DWG # V049-8-153

ITEM	QTY.	PART NO.	DESCRIPTION	BAR, 1.50 THK, 3.00 WD, 42.50 LG
PART LIST			MATERIAL SPECIFICATION 304L STAINLESS	
UNLESS OTHERWISE SPECIFIED DIMENSIONS ARE IN INCHES TOLERANCES ARE: DECIMALS ANGLES FINISH XX ± .01 ± 10' 125' XXX ± .005		CONTRACT OR SALES ORDER NO.		GNB Corporation SCIENTIFIC AND INDUSTRIAL EQUIPMENT 30971 San Benito Court HAYWARD, CALIFORNIA 94544 (510) 441-1900 FAX: (510) 441-0930
THIRD ANGLE PROJECTION		APPROVALS		
DO NOT SCALE DRAWING		DATE		
D103236	USED ON	CADD FILE NAME	ENGINEER	DATE
		B103249E	ZH	1-24-96
SCALE: NONE			TITLE	REV.
			INNER BEAM G44	E
			DWG NO. 103249	
			SHEET 1 OF 1

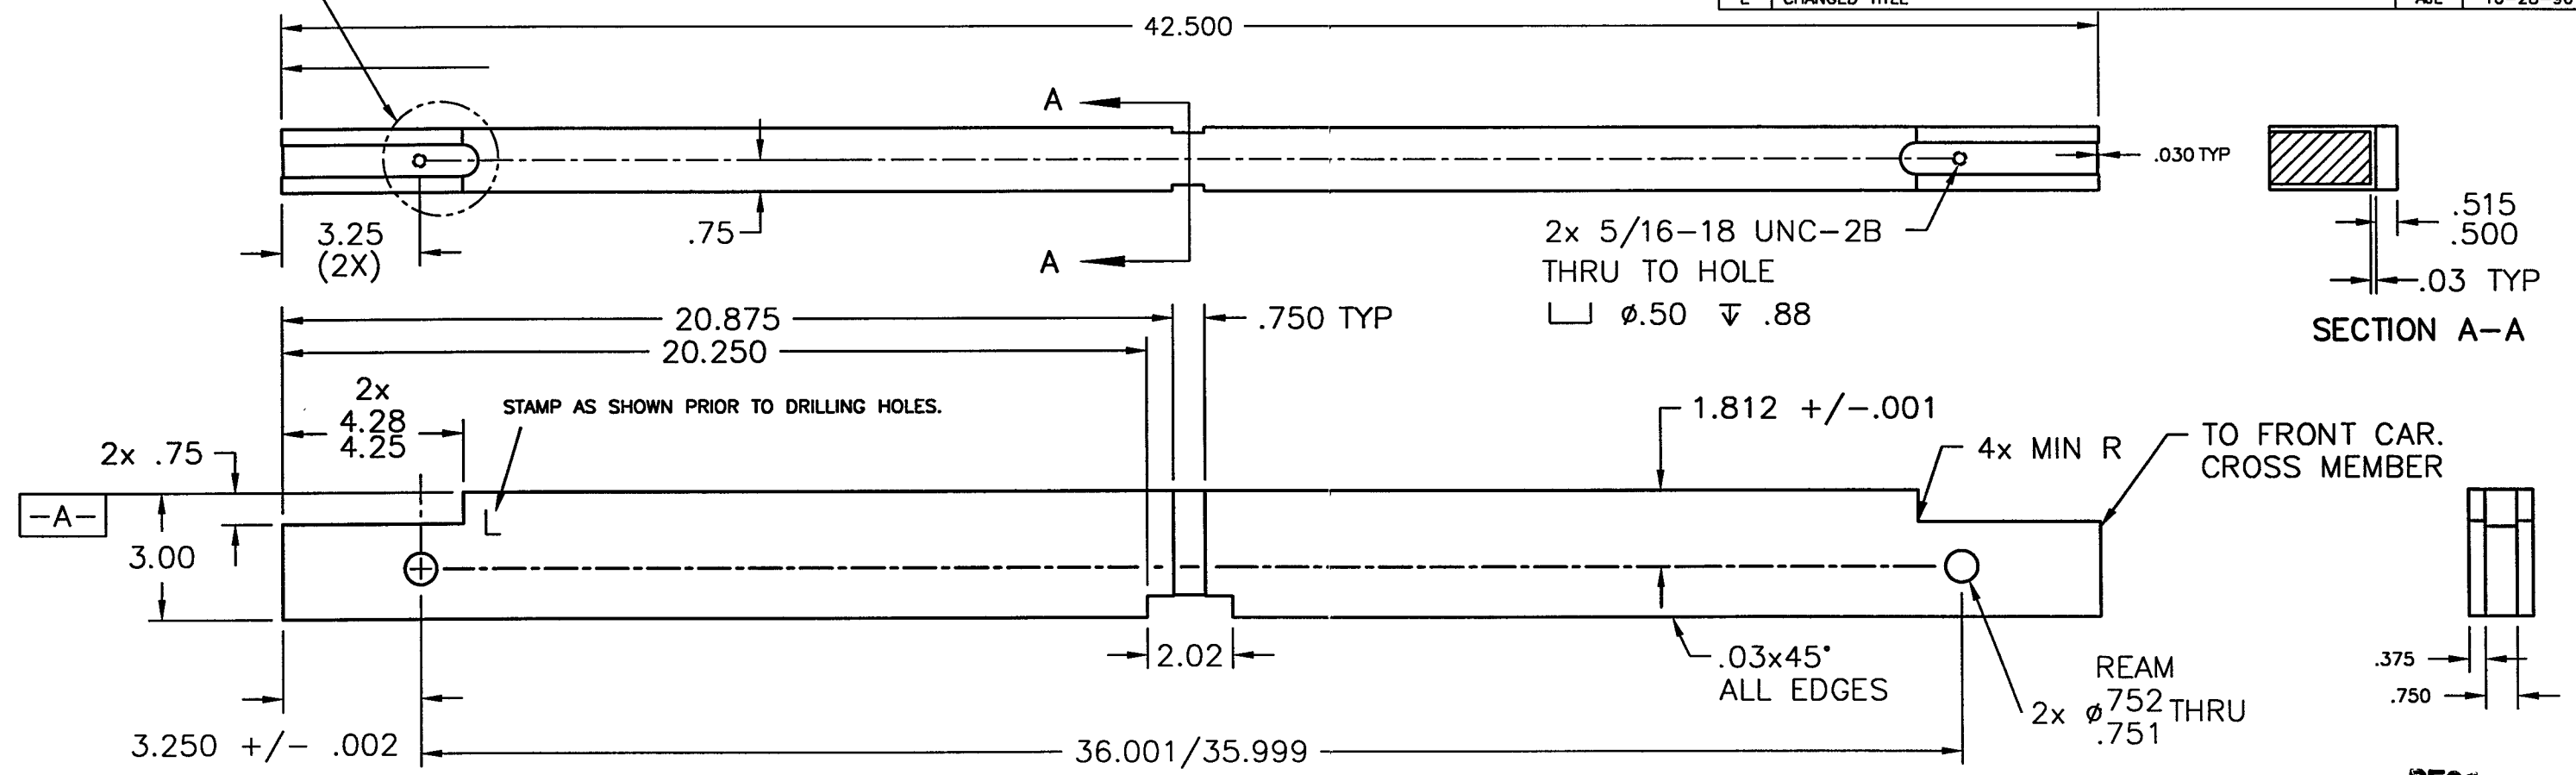
REVISIONS			
REV.	DESCRIPTION	APPROVED	DATE
A	RELEASED		
B	REMOVE No.4 FINISH, 5/16-18 WAS 1/4-20		2-8-96
C	DELETED TWO HOLES; .03 WAS .13; ADDED +/- .001 TOLERANCE TO 1.812 DIM; REAM .752/.751 WAS .761/.751; 3.250 DIM WAS 3.000; 2.02 WAS 2.03; ADDED 36.000 DIM; ADDED STAMPING INSTRUCTION	AJL	7-16-96
D	42.500 WAS 42.50; REDRAWN	AJL	9/18/96
E	CHANGED TITLE	AJL	10-28-96
